CITY OF CARMEL-BY-THE-SEA HISTORIC RESOURCES BOARD AGENDA

- 3) **DS 25240 (Ramos):** Consideration of a Determination of Consistency with the Secretary of the Interior's Standards for Design Study application, DS 25240 (Ramos), for after-the-fact revisions to a previous

TO: Historic Resources Board Members
SUBMITTED BY: Katherine Wallace, Associate Planner
SUBJECT: **DS 25240 (Ramos):** Consideration of a Determination of Consistency with the Secretary of the Interior's Standards for Design Study application, DS 25240 (Ramos), for after-the-fact revisions to a previous approval (DS 23396) that include the removal of roof shingles, horizontal wood siding, wood shingle siding, wood windows, and a Carmel stone chimney, replaced with new at the historic "Rockwell House" located on the northeast corner of San Antonio and 12th Avenues in the Single-Family Residential (R-1) Zoning District and the Beach and Riparian Overlay District. APN 010-279-008-000

PROPOSED ELEVATION

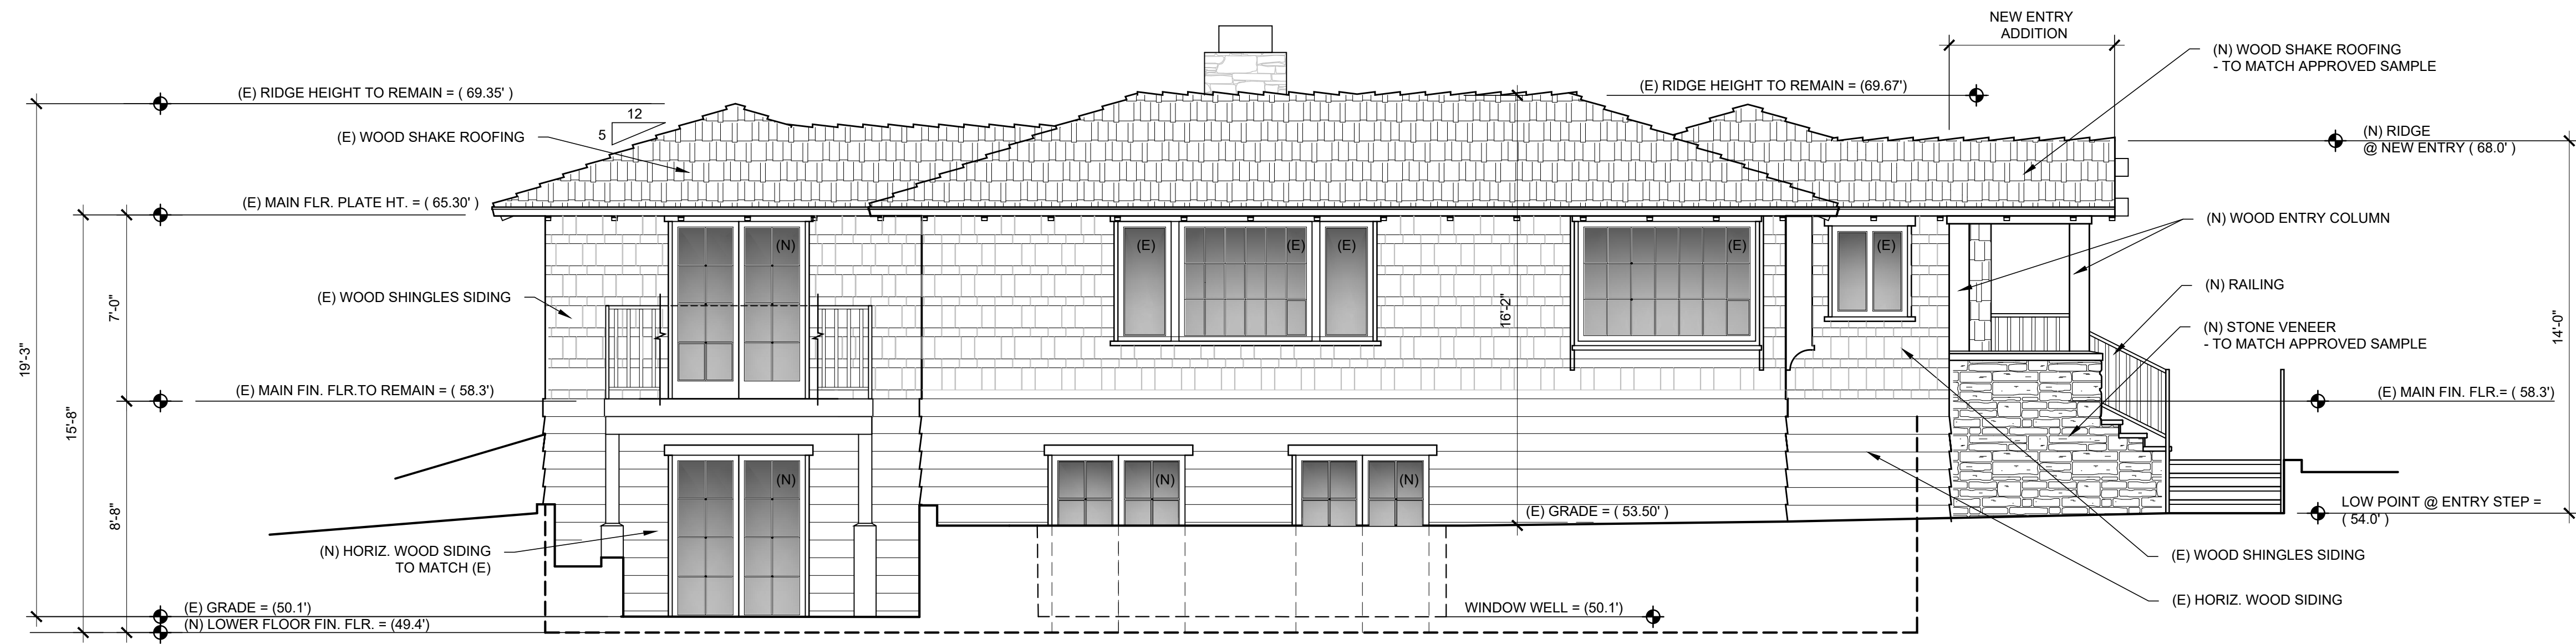
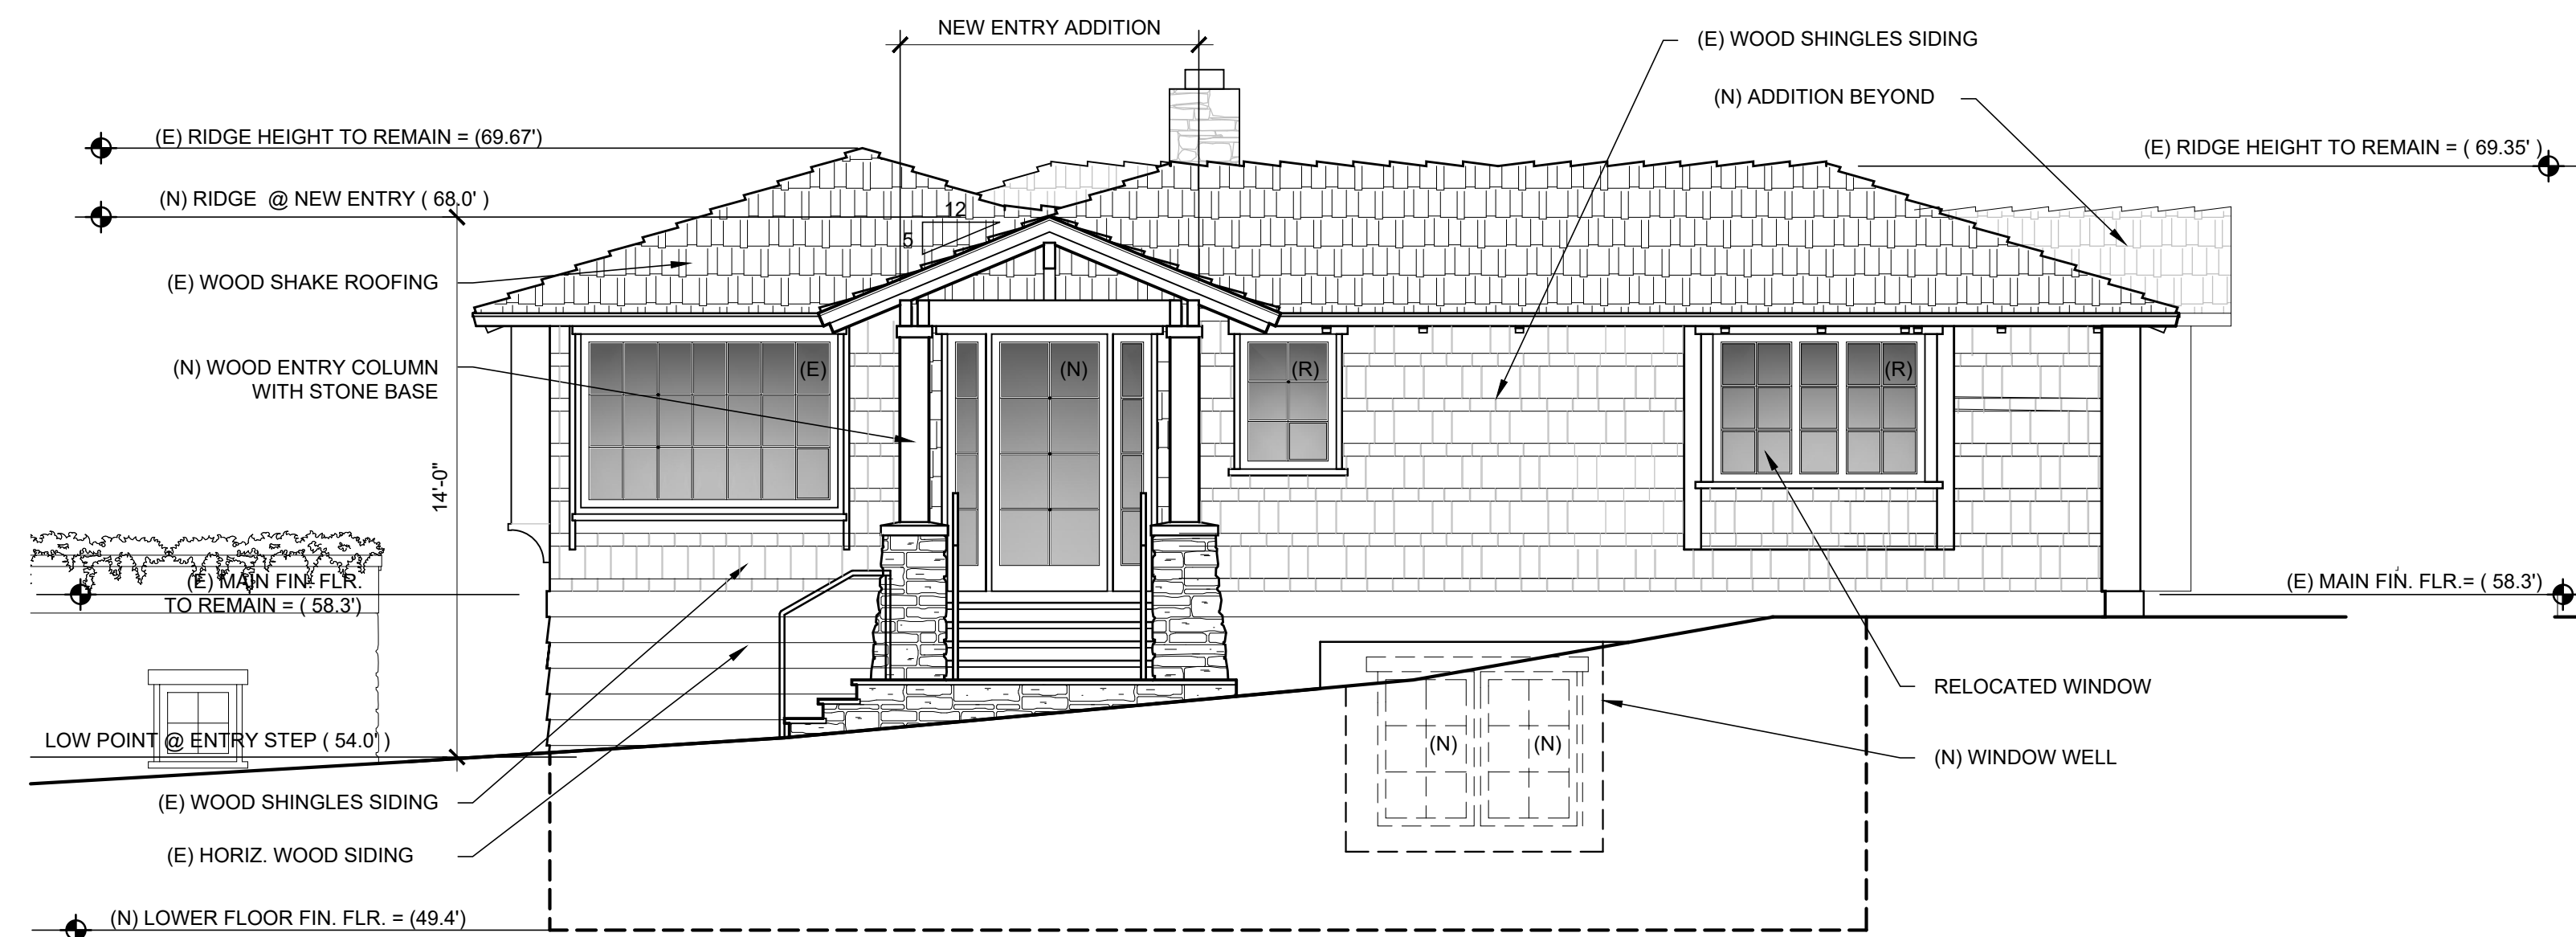
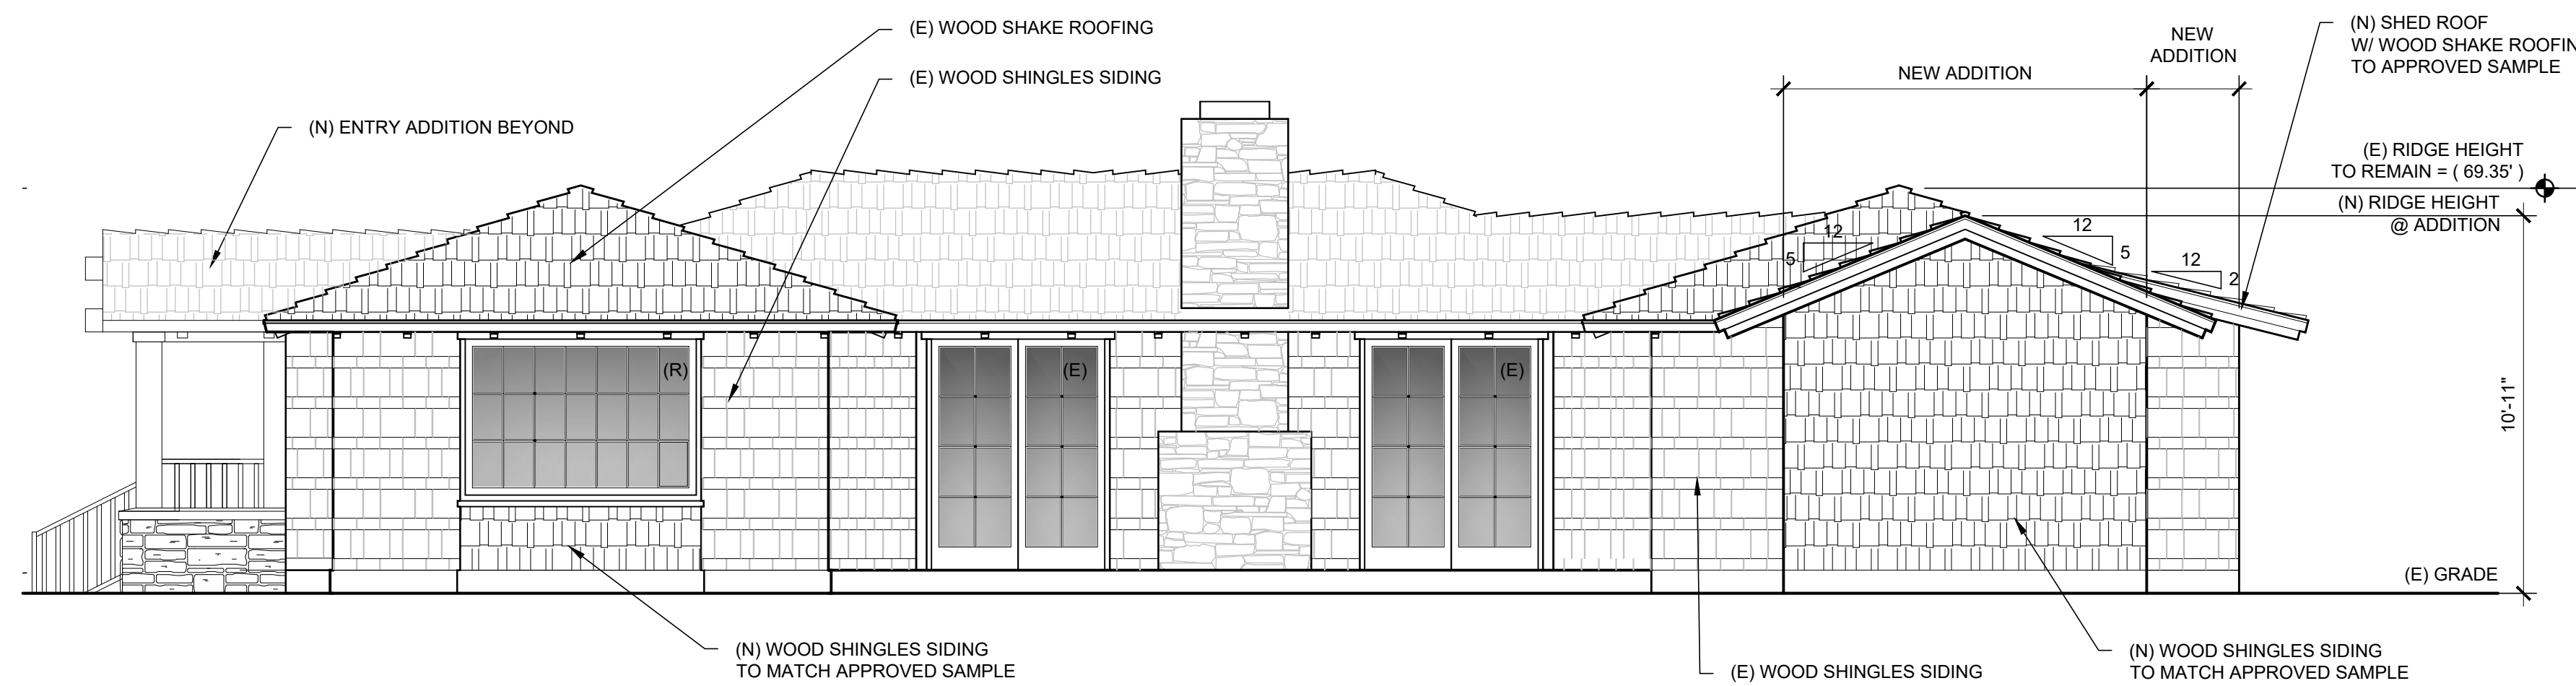
Most of the windows in the Rockwell House were slated to be retained and repaired, however, most of the windows were replaced like for like due to deterioration. According to the National Park Service, “like for like” refers to replacing or repairing deteriorated features of a historic property with materials or elements that closely match the original characteristics. Standard 2 and Standard 6 provide guidance for determining the appropriateness or repair vs. replacement.

In addition to the wood shingle siding, the wood horizontal siding on the lower level of the west elevation was also removed and replaced. This siding was originally indicated on the plans to remain. However, it is likely that the siding did not date to 1923, as the basement area where the siding was located was previously disturbed in 1984 when new window openings were installed. Since the horizontal siding was likely outside the

Lastly, the original project authorization was conditioned to require differentiated shingle siding on the new additions. To be consistent with Standard Nine, any new siding used in the additions should be differentiated from the existing siding, so the additions are clearly discernable from the historic house (replacement siding on the original house should match in kind, but siding on any additions should be differentiated). However, the shingles installed on the additions match the original “ribbon course” shingle pattern of the historic house (see Figure 6 in the Phase II Addendum). To differentiate the shingles on the additions, the architect and contractor have suggested removing 5/8” from selected shingles along the shingle course to create a staggered pattern (see Plan Sheet A3.1, Attachment 6). This solution will differentiate the new additions and meet the requirements of Standard Nine.

Based on the recommendations of the qualified professional, Margaret Clovis, the after-the-fact project components are consistent with the Secretary of the Interior's Standards for the Treatment of Historic Properties, except for the new chimney and the non-differentiated wood shingles on the additions. As such, staff recommends the Board incorporate condition of approvals as part of the determination. The conditions shall require that prior to approval of the Design Study (DS 25240), the owner/applicant shall submit modified plans to staff that demonstrate:
